Dam Safety Review

Dam Safety Review
Sewage Lagoons and Water Reservoir
Cape Dorset, Nunavut

OTT-00209248-A0

September 13, 2013

TITLE
LAGOON CONTAINMENT BERMS
AND TRUCK TURNAROUND PAD

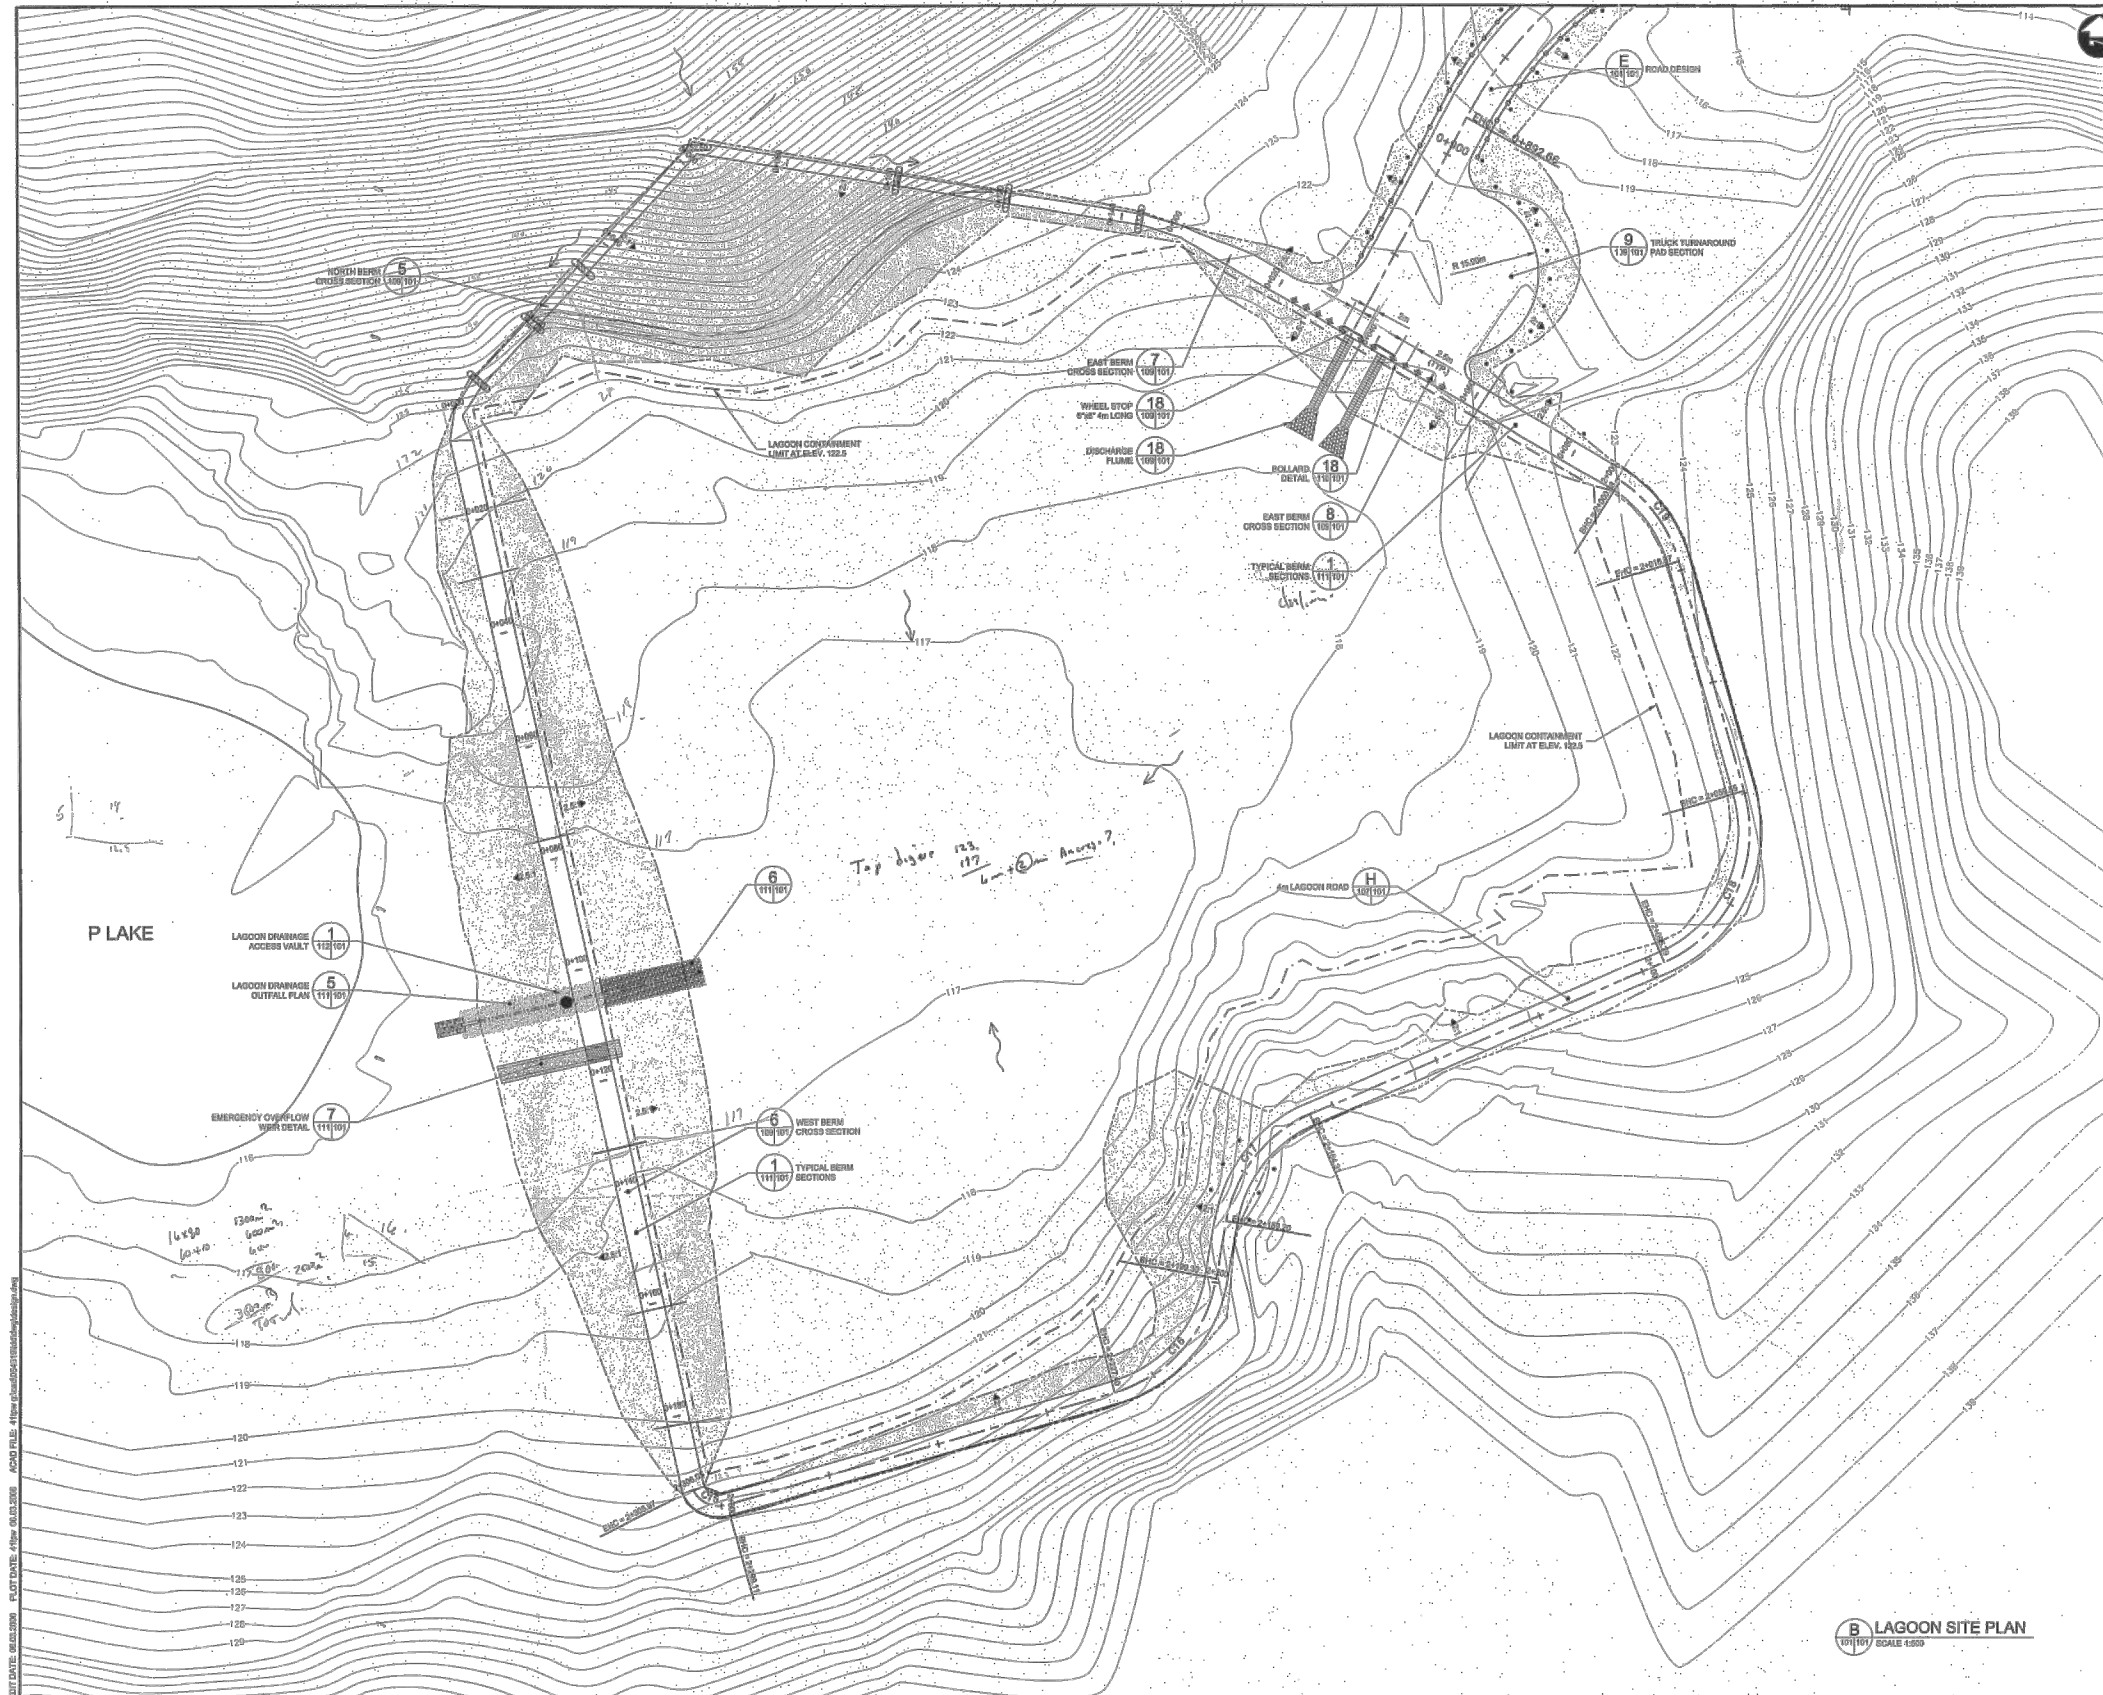
The road on top of the berms varies considerably in grade since the north and south berms have been constructed to follow the natural contours. The south berm elevation approaching the knoll varies from Elevation 125 m to Elevation 130 m with a gradient of 9 percent. The north berm road elevation approaching the top of the knoll varies from Elevation 125 m to Elevation 128 m at a grade of approximately 30 percent resulting in a blind spot (Photo 3). In addition, there is a bend in the berm on top of the hill.

The lagoon road located on the north berm is narrow and has been constructed at a very steep gradient, which has resulted in a blind spot until top of the hill is reached. At this location, there is also a bend in the road, which constitutes dangerous driving conditions, specifically during the winter months with snow and icy conditions. It is recommended that the road should be lowered by 3 m approximately so its elevation is close to that of the west berm. In addition, the road should be widened. It is noted that lowering of the elevation of the road would necessitate blasting of the bedrock.

6 WEST BERM SECTION 0+140
SCALE 1:2000

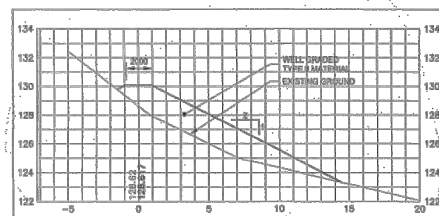
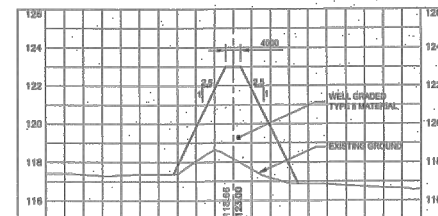
The valley at the location of the west berm is approximately 170 m wide. The ground surface elevation of the valley floor at the west berm location varies from Elevation 123 m to Elevation 117 m approximately. The maximum height of the berm is therefore in the order of 6 m. The berm has been designed with crest elevation of 123.0 m. Its design upstream and downstream slopes are at an inclination of 2.5H:1V (Figure 5). The core of the berm comprises of sand and gravel fill (Type II Granular B). Design drawings also indicate 300 mm thick layer of rip rap to be placed along the downstream slope of the berm. The design drawings also required a bentonite liner to be installed vertically close to the centre of the cross-section of the berm extending from approximately 0.5 m below the crest of the berm into bedrock.

- 1.) The west berm is approximately 4 m wide and with side slopes of 2.5H:1V. It has been constructed with sand and gravel fill in accordance with the project specifications. The upstream and downstream slopes of the berm have been provided with rip rap.
- 2.) At the time of the visit, the west berm of the lagoon was leaking from an area south of the emergency overflow weir. The leak was observed to take place at the interface of the berm and the natural ground. However, a representative of the Government of Nunavut indicated that

during the spring melt, water was also observed to seep through the berm in this area. The representative also indicated that during construction, the design of the berm was modified and that the bentonite liner was not installed vertically in the centre of the cross section of the berm but along the downstream slope of the berm. Currently, it is not known whether the liner was sealed into the bedrock.

It is considered that the leakage of the lagoon is due to one or more of the following factors:

- a.) The liner has been damaged during construction since the rip rap contains sharp edges;
- b.) The liner was not sealed into the bedrock; and
- c.) Joints in the liner may be defective or may have opened subsequent to installation of the liner since the joints of a bentonite liner are not sealed but are merely overlapped with bentonite beads placed in the overlap.

It is recommended that the liner should be replaced as soon as possible since side slopes of 2.5H:1V for a seepage berm are not considered stable. The downstream slope of the berm is susceptible to failure. It is recommended that the bentofix liner should be replaced as it cannot be repaired.

For this purpose, it would be necessary to pump the lagoon dry, remove the rip rap and any underlying materials to expose the liner. The liner should be removed and discarded. The new liner should be sandwiched between 150 mm thick sand layers. It should be embedded at least 0.5 m into the bedrock. A minimum of 300 mm of Type II granular material should be placed on the sand cushion on top of the liner prior to placing the rip rap. Extreme care should be exercised during the placement of the rip rap to ensure that the liner is not damaged.

20 DISCHARGE FLUME SECTION
SCALE 1:50

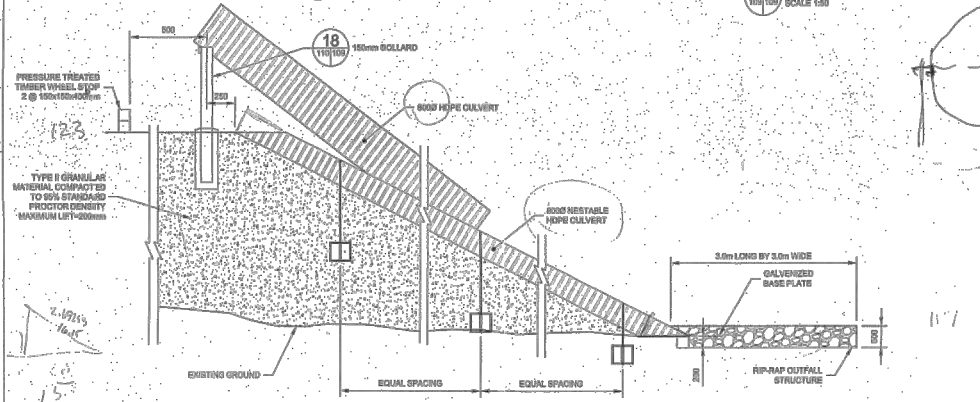
The discharge flume comprises of an 800 mm diameter heavy duty polyethylene (PE) pipe which discharges into a 1200 mm diameter nesting heavy duty PE pipe set on the berm slope. A galvanized base plate and rip rap has been provided at the location where the effluent is discharged into the lagoon by the trucks to prevent erosion (Figure 6).

The discharge chute and turning circle are located along the east berm where the access road approaches the lagoon. The Hamlet has indicated that the discharge chute is located downwind and as such, it would be difficult for the truck drivers to discharge the effluent. The Hamlet would like another discharge chute to be located in the north west corner of the lagoon and a turning circle in the south west area of the lagoon. This would enable the effluent to be discharged from one of the two discharge points depending on the direction of the prevailing wind.

It is recommended that these improvements should be implemented as they would result in safer operating conditions.
